**DEFENSE NUCLEAR FACILITIES
SAFETY BOARD**

August 27, 2019

Staff Report

Safety Issues Relating to the Waste Isolation Pilot Plant Safety Significant Confinement Ventilation System

Figure A-2. Existing WIPP underground layout

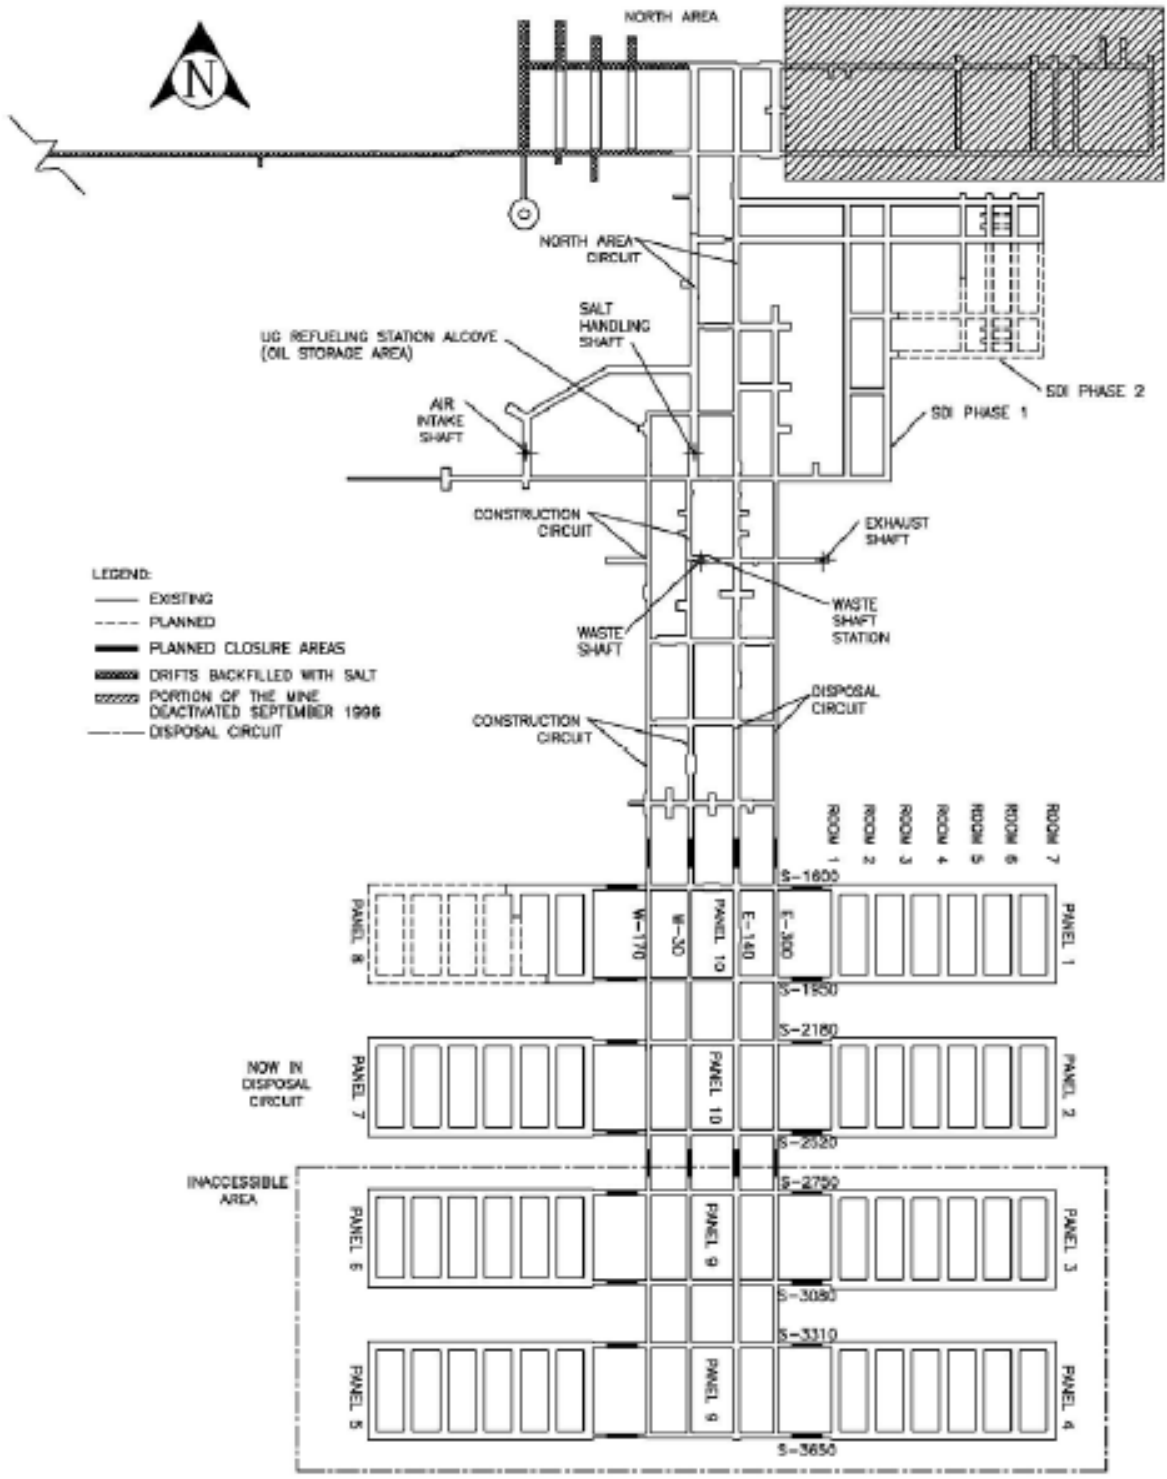
The targeted volumetric flow rate through the waste shaft station is between 20,000 and 25,000 cubic feet per minute (cfm). WIPP recommends this flow rate to maintain the required differential pressure across bulkhead (BH) 308 [3] and to ensure air from the waste shaft station is filtered and air is flowing from the non-contaminated to the potentially contaminated areas. WIPP defines the waste shaft station as the underground area between the waste shaft and the intersection between S-400 and the E-140 drift, which can be seen in Figure A-3 [2].

The transient time analysis assumes a radiological release from Panel 9 or 10. These two panels do not currently exist in the WIPP underground. WIPP is emplacing waste in panel 7 and mining in panel 8. The Board’s staff team considers that the assumptions and conditions used to calculate the transport time from panels 9 and 10 might be similar to those that could be used for calculations assuming that the release originated from the existing panels 7 and 8. However, the Board’s staff team considers that the assumptions and scenarios are not conservative in either case. In addition, SSCVS could be completed and running before panels 9 and 10 are built and ready to emplace waste.

Figure A-3. Simplified diagram with potential CAM locations for the three cases evaluated.

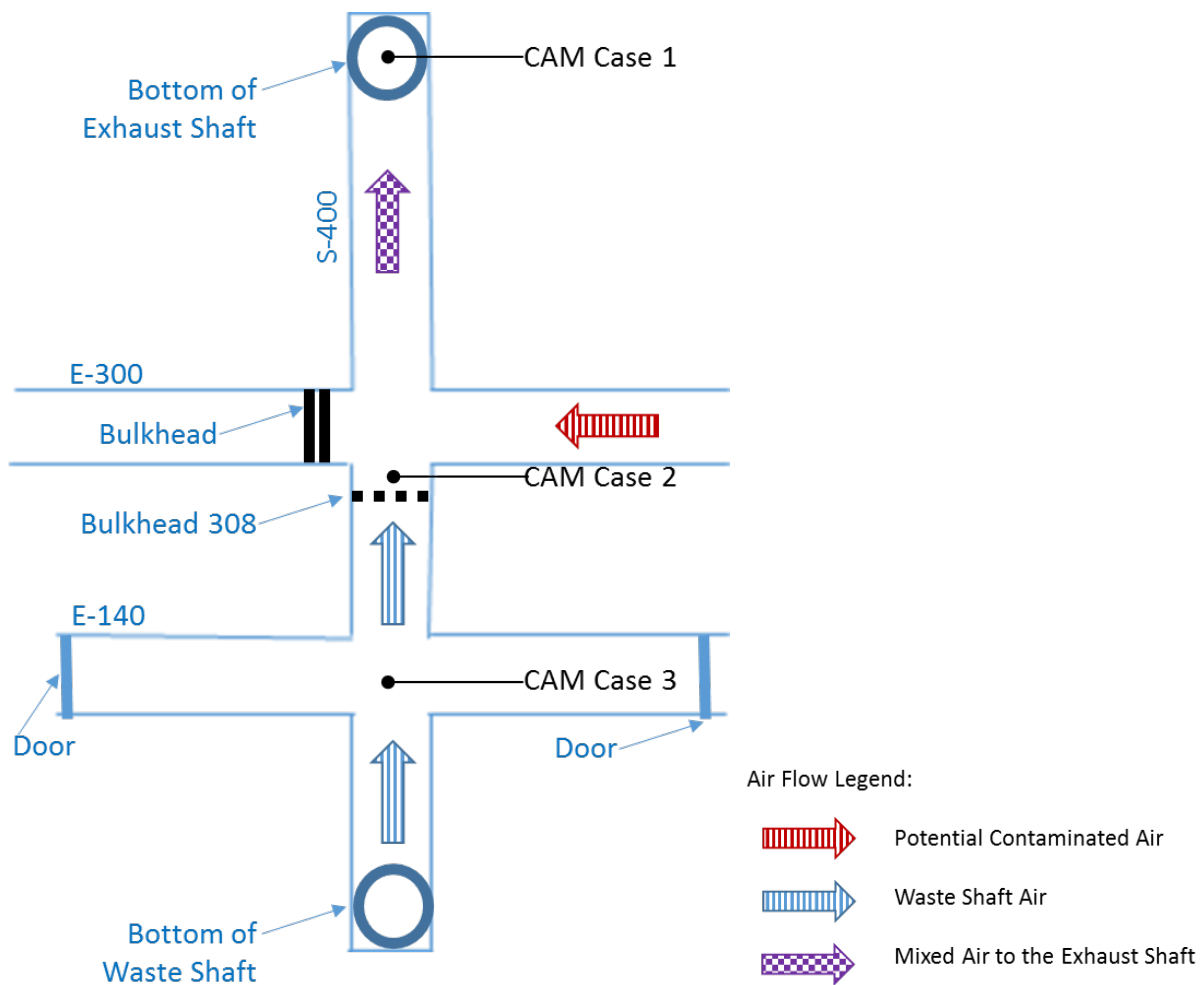
This analysis evaluates three cases. The radiological releases of the three scenarios evaluated take place in the underground waste shaft station located between the waste shaft and exhaust shaft. The Board's staff team selected this area due to the proximity of the waste shaft station to the bottom of the exhaust shaft. The three cases evaluate the following anticipated events at the waste shaft station and transport path: fire, deflagration/over pressurization, impact, and spontaneous combustion (e.g., CH/RH-UG-02-001a, CH/RH-UG-02-002a2, CH/RH-UG-02-002a3, CH-UG-01-001a2, CH-UG-06-001a, CH/RH-UG-10-003a, CH/RH-UG-01-005a1, CH/RH-UG-10-005a), when the underground ventilation system is credited as a mitigative control. The main differences between the three cases is the magnitude of the event and the location of the CAMs (see Figure A-3).

First Case—In the first case, the Board's staff team assumed that the anticipated event would be an explosion or high energy event of sufficient magnitude to push radiological contamination from the waste shaft station toward the exhaust shaft. The magnitude of this anticipated event would be similar to the design basis accidents (DBA), which contemplate a fuel operated vehicle and/or a vehicle carrying waste dropping from the waste shaft collar (i.e., CH/RH-UG-01-005a1 and CH/RH-UG-10-005a). This scenario assumed that CAMs would still work during and after the explosion and that any CAM located between the waste shaft and BH-308 would detect airborne contamination and send the signal to automatically start closing the isolation dampers. As illustrated in Figure A-3, BH-308 is located between the waste shaft and the exhaust shaft. However, BH-308 is not a safety component and for that reason it cannot be credited during these events. For this reason the Board's staff team also assumed that BH-308 is nonexistent and contamination is pushed almost instantaneously to the bottom of the exhaust shaft during this scenario. Thus there is no practical difference between detection times for any of the three potential CAM locations.

Second Case—The second case assumed detection by a CAM located next to BH-308 and takes into consideration the distance between BH-308 and the bottom of the exhaust shaft. The cross-sectional area of the S-400 drift and maximum SSCVS volumetric flow rate are used to calculate the air stream velocity; factoring in the travel distance yields the transport time. This volumetric flow rate is used due to the short distance between BH-308 and drift E-300 (see Figure A-3). The Board’s staff team assumed that any radiological release detected in the vicinity of BH-308 accelerates almost immediately to the air stream velocity of the E-300 drift in the direction toward the exhaust shaft.

Third Case—The third case assumed detection by a CAM located at the intersection of the S-400 and E-140 drifts. This case takes into consideration the additional distance between the intersection and BH-308. Once again the air stream velocity is inversely proportional to the cross-sectional area of the flow path. In the third case, the smallest area and higher velocity is at the BH-308 dampers. The cross-sectional area at BH-308 also could fluctuate based on the damper free area¹.

Figure A-4. Bulkhead 308 Front View

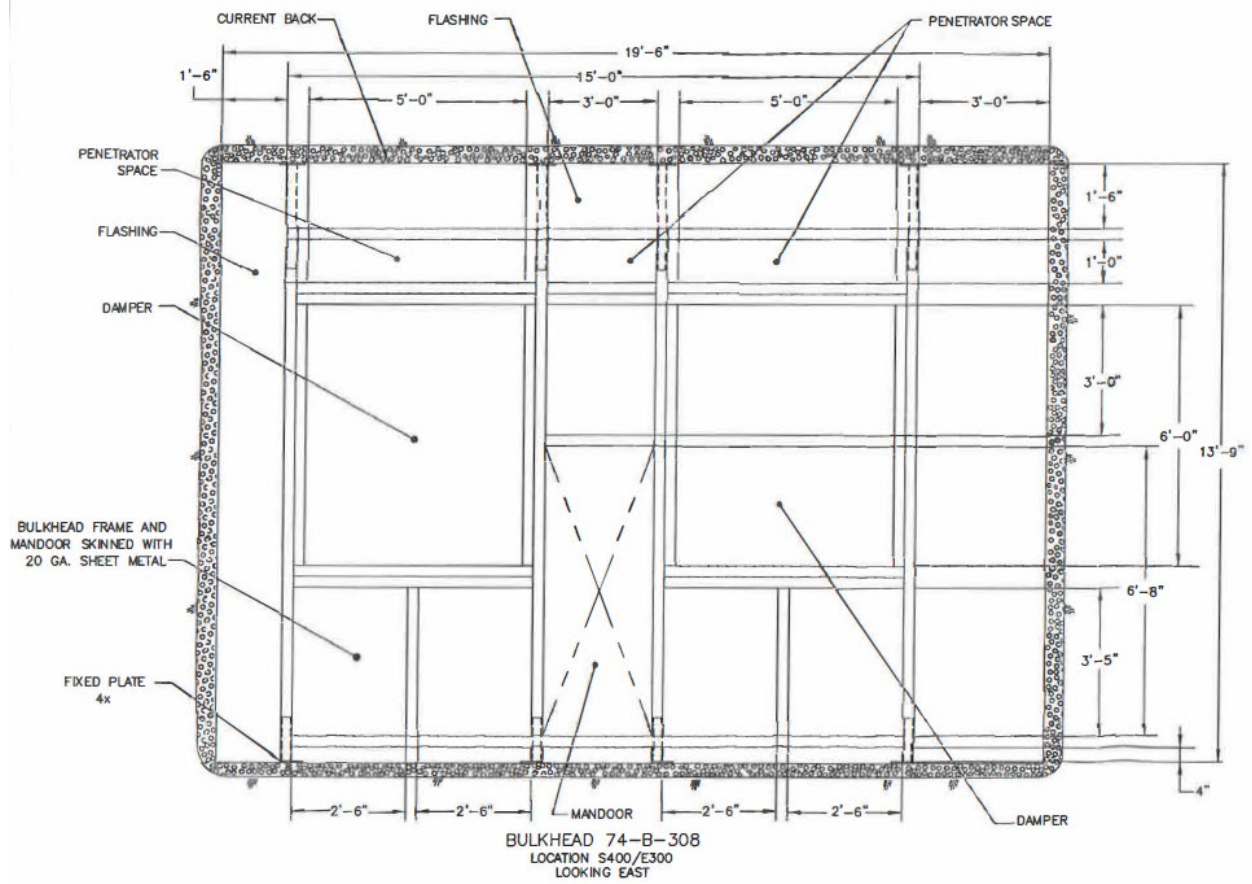
In this case, two main cross-sectional areas are used to calculate two different transport times. One area calculation uses the S-400 drift cross-sectional area and the second calculation uses the BH-308 damper cross-sectional area. The Board's staff team used the area of BH-308 as an approximation of S-400 drift cross-sectional area (Figure A-4). The dimensions of this area are 19'6" by 13'9" for an area of 268.13ft² [7]. Each BH-308 damper has dimensions of 5' by 6' for an area of 30ft² for a single damper and 60ft² for two dampers. However, assuming the damper blades occupied 50 percent of the area, the damper free area for the two dampers would be 30ft². The volumetric flow rate of 25,000cfm, used between the intersection and BH-308 for this calculation, is the approximate target volumetric flow rate used to keep the differential pressure across BH-308 and the same flow rate used in the SRK transient time analysis [4] when BH-308 dampers are mostly open.

The maximum allowed volumetric air flow rate calculated for a 50 percent damper's cross sectional area is 17,000cfm, which is below the recommended 25,000cfm to maintain the required differential pressure at BH-308. Any flow rate above that value would increase the likelihood of contaminated air reaching the isolation damper before it is completely closed. This would cause a potential release of contaminated air to the environment.
